MEMORANDUM

To: Planning, Land Use and Zoning Committee
From: Ketil Freeman and Lish Whitson, Council Central Staff
Subject: Uptown Rezone: Draft Amendments and Resolution

Attachment B:
Amendment 1A: Rezone the Heart of Uptown

Amendment to Attachment 1: Uptown Rezone Map

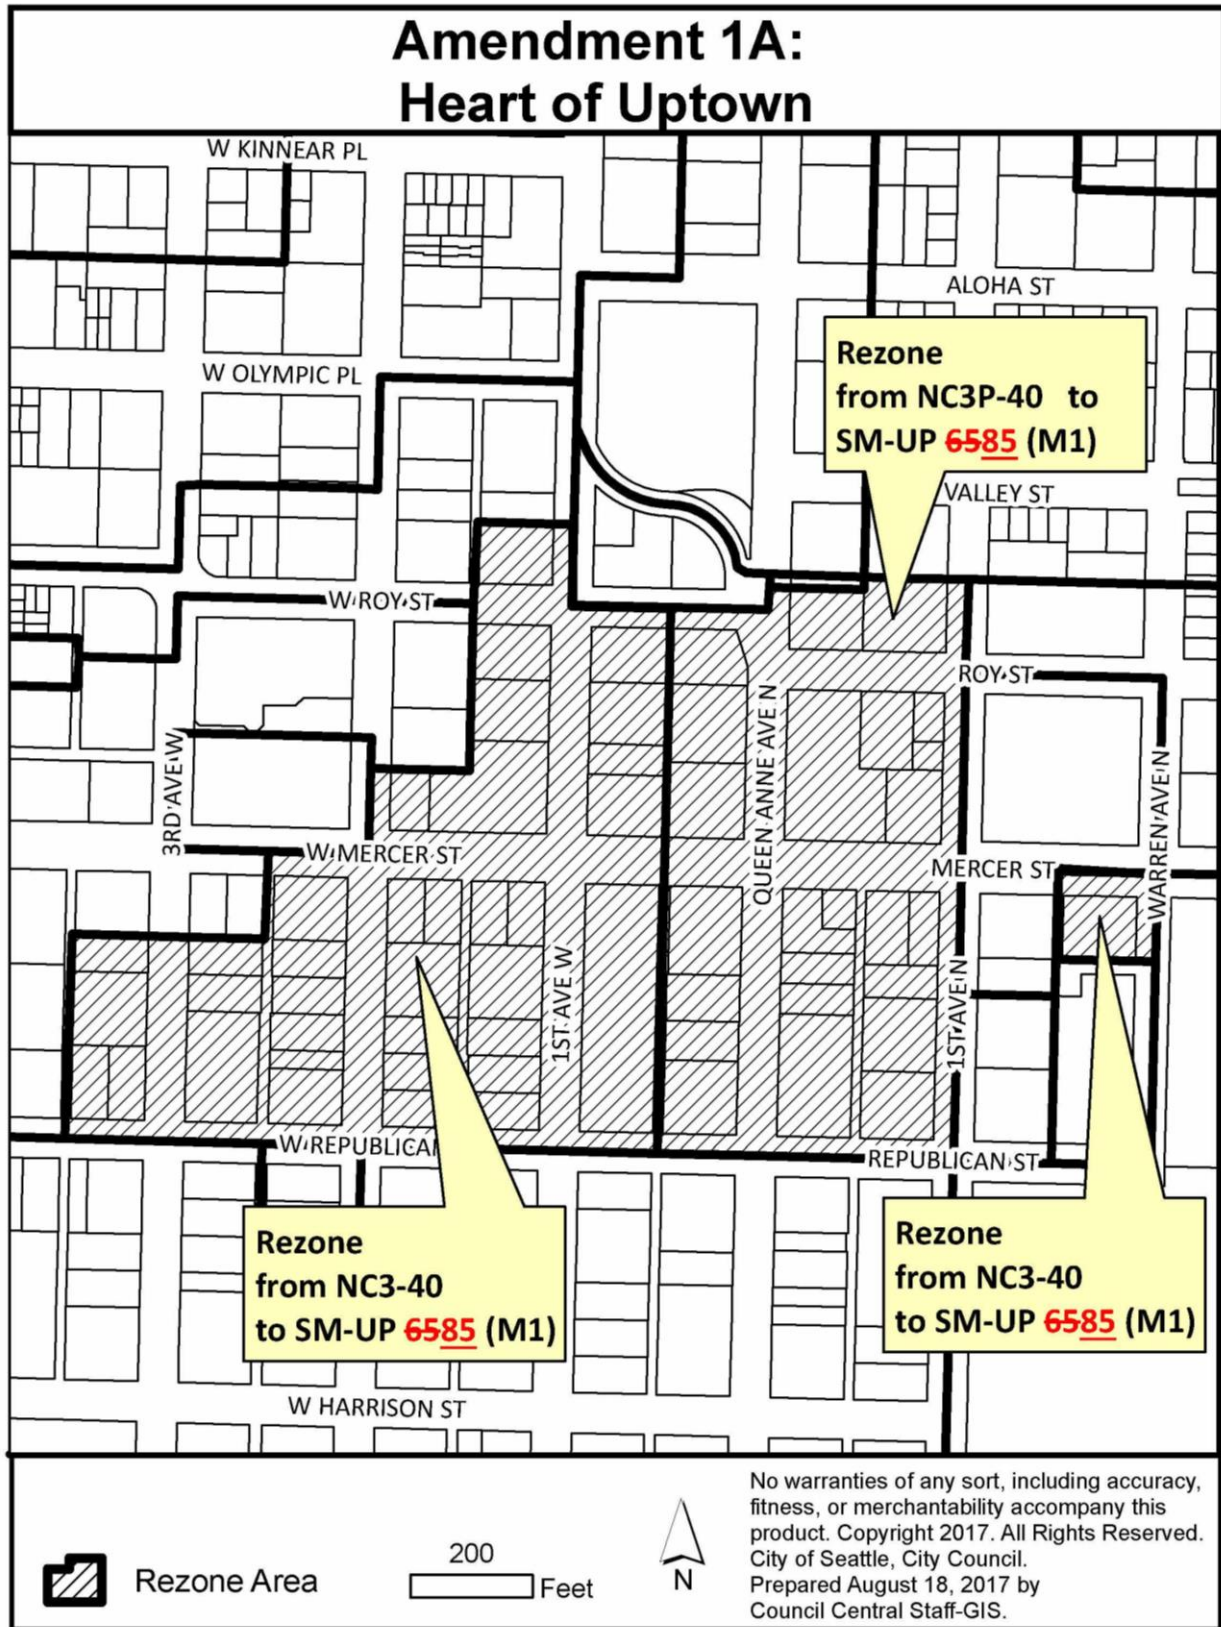
This amendment would rezone property north of Republican Street to SM-85 (M1), rather than the proposed SM-65 (M1). The 85 foot zone would allow two more stories of development, and 0.75 additional FAR.

Under the Mayor's proposal, the Heart of Uptown – the area generally bounded by N/W Republican Street, 2nd Avenue W, 1st Avenue N and N/W Roy Street would be surrounded by 85 foot zones to the south and east. To the west would be a Midrise zone with a Mandatory Housing Affordability suffix, which would allow buildings up to 80 feet.

The proposed amendment would provide a transition along Queen Anne Avenue N to the north by not rezoning the northwest corner of W Roy Street and Queen Anne Avenue N.

Map A for 23.48.735

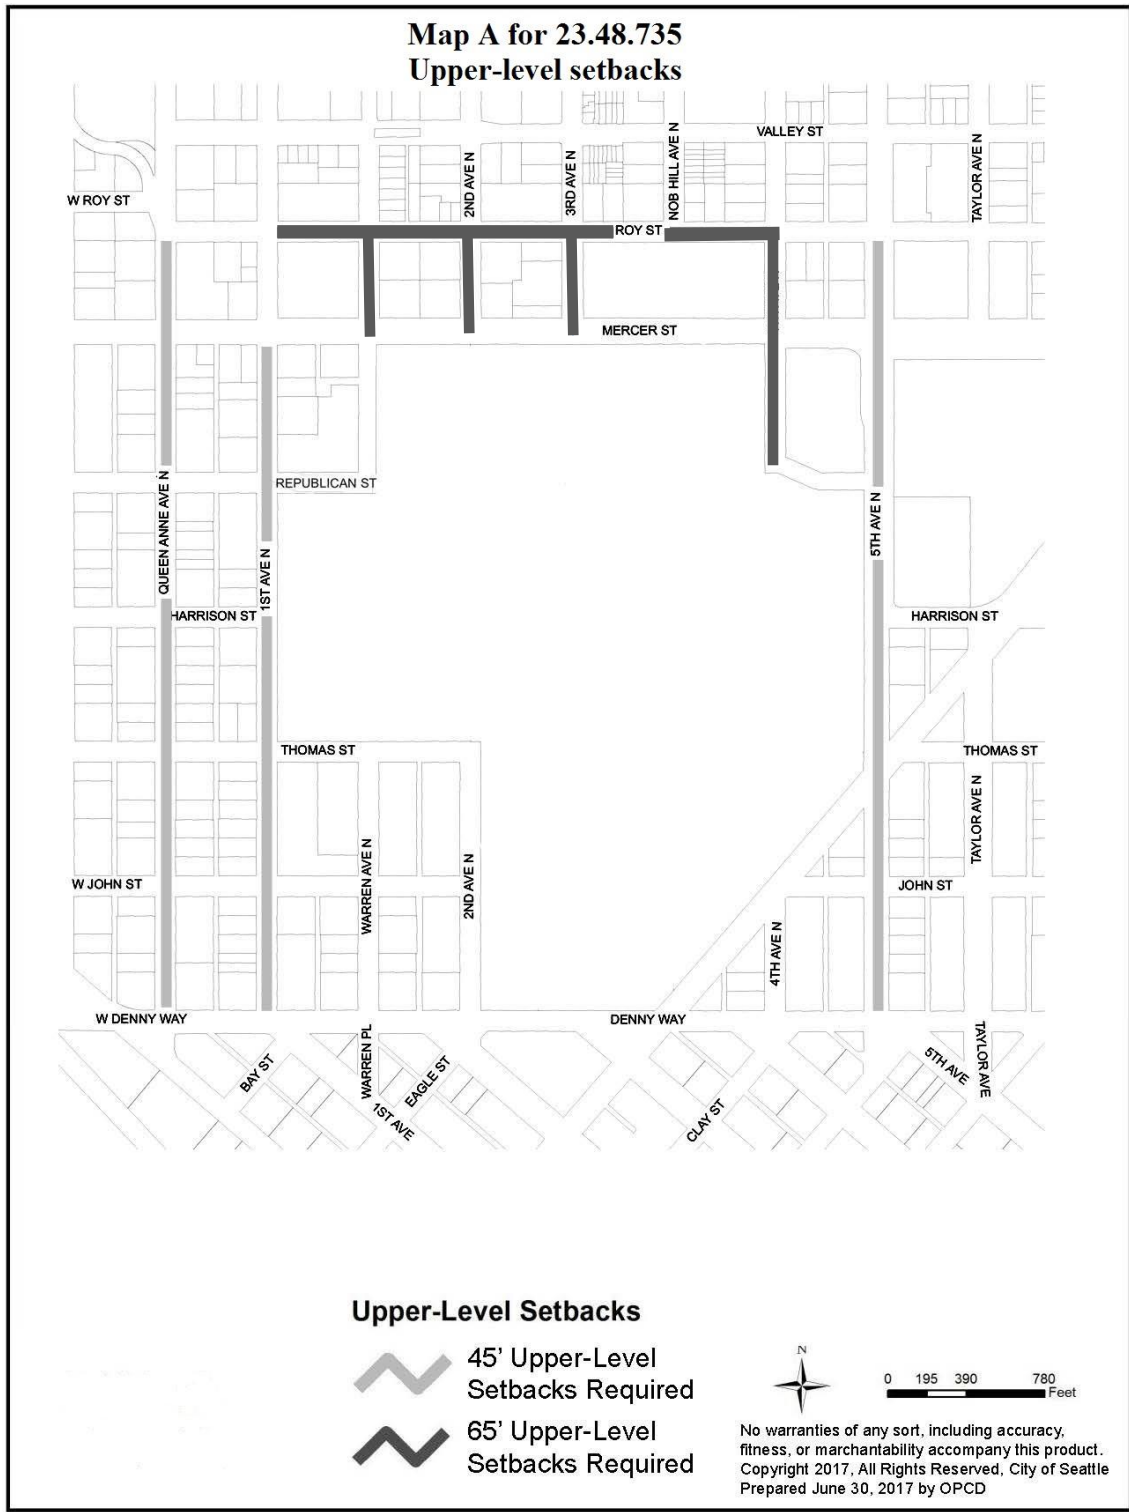
The Executive has proposed ten foot setbacks along Roy Street above 65 feet, this amendment would also apply those setback requirements on the north-south streets in this area in order to allow for larger view corridors down these streets.

Amendment to Attachment 1: Uptown Rezone Map

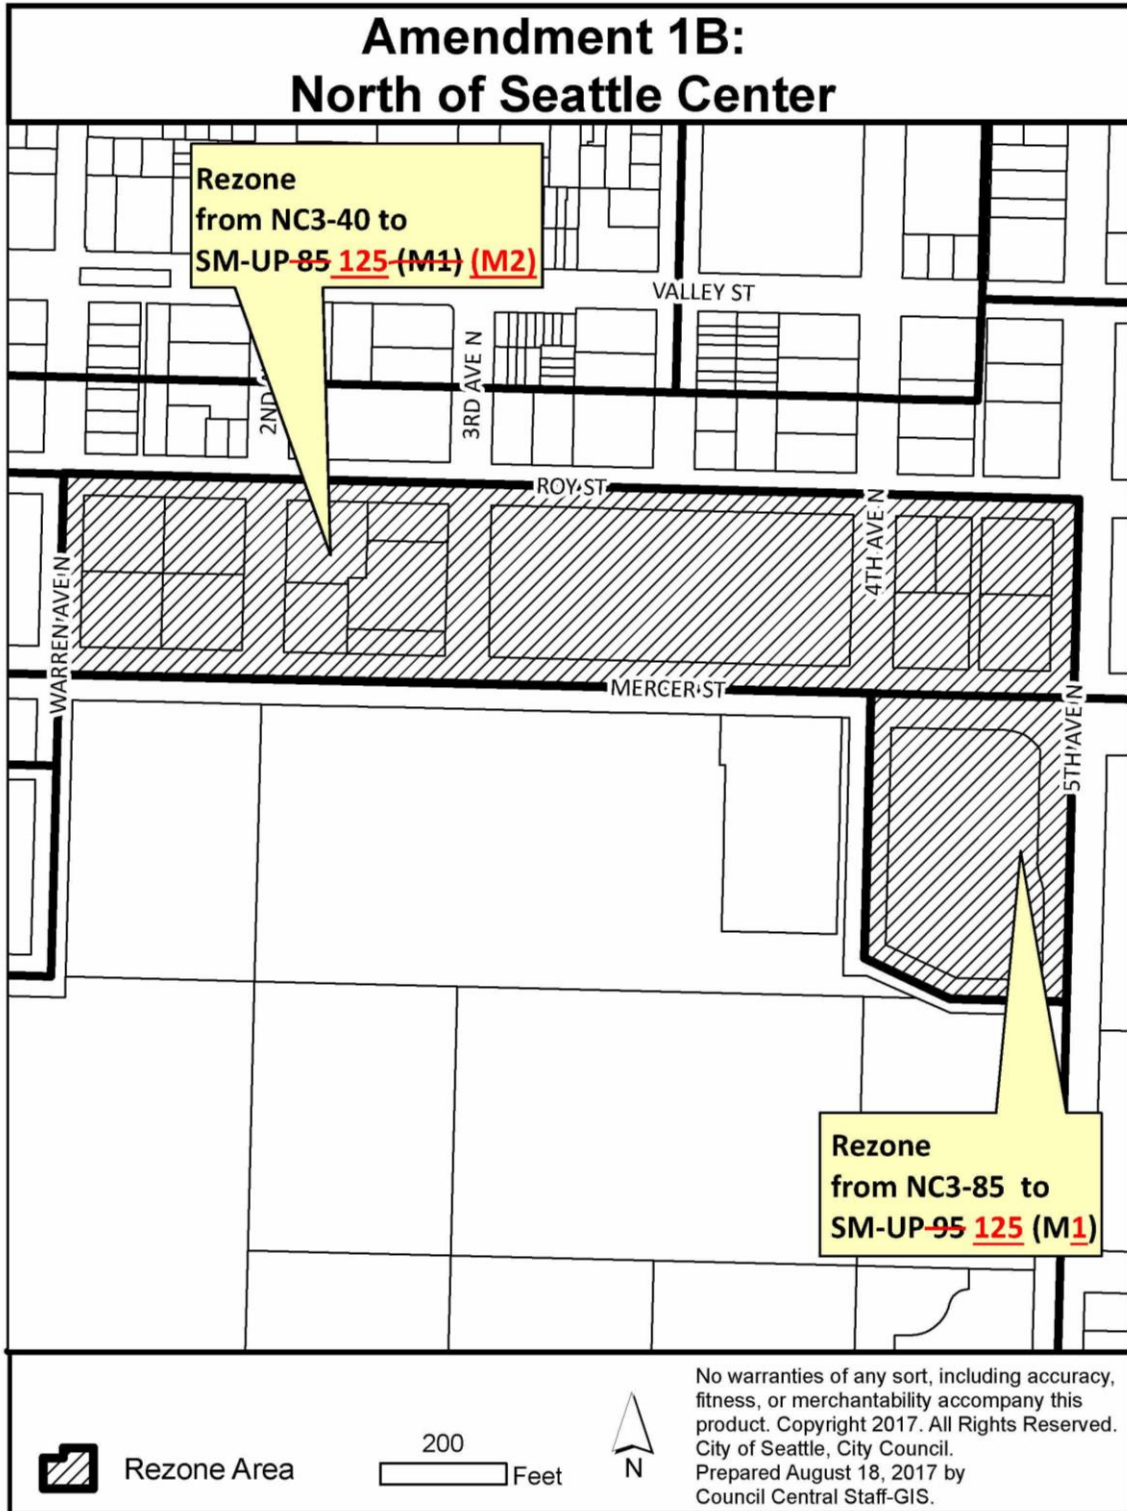
This amendment would rezone property between Roy and Mercer streets and 1st Avenue North and 5th Avenue North, and the block between Republican and Mercer streets and 4th Avenue North and 5th Avenue North from NC3-40 to SM-UP 125. The Executive has proposed 85 feet for these blocks.

**Map A for 23.48.735
Upper-level setbacks**

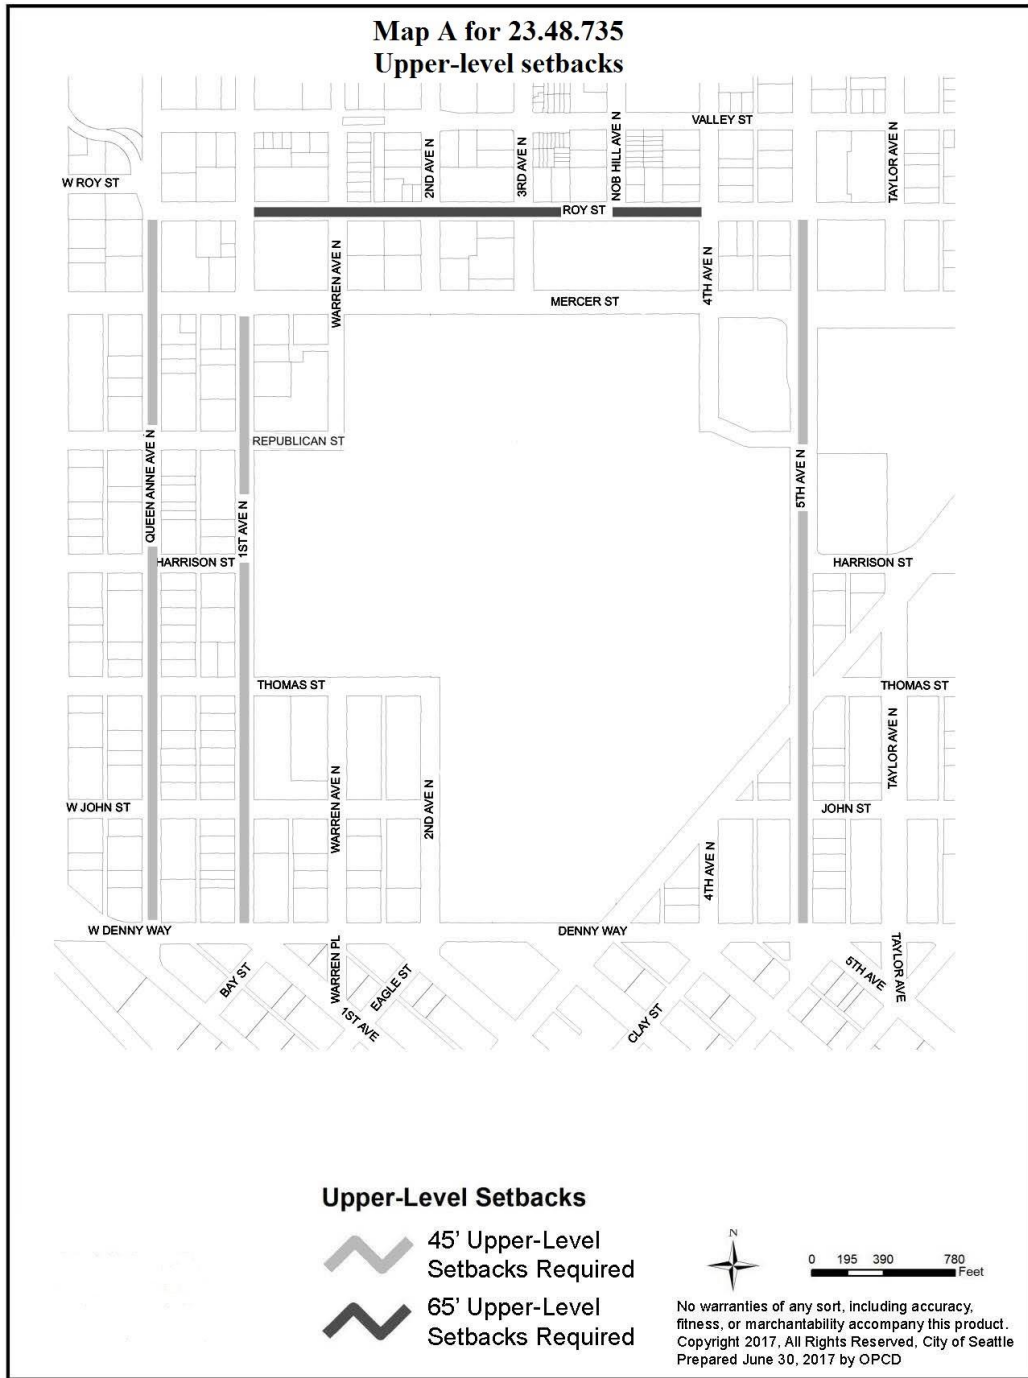
A. In all SM-UP zones, any portion of a structure greater than 45 feet in height or 65 feet in height must be set back from a lot line that abuts a designated street shown on Map A for 23.48.735. A setback of an average of ~~10~~ 5 feet from the front lot line is required for any portion of a structure exceeding the maximum height that is permitted without a setback.
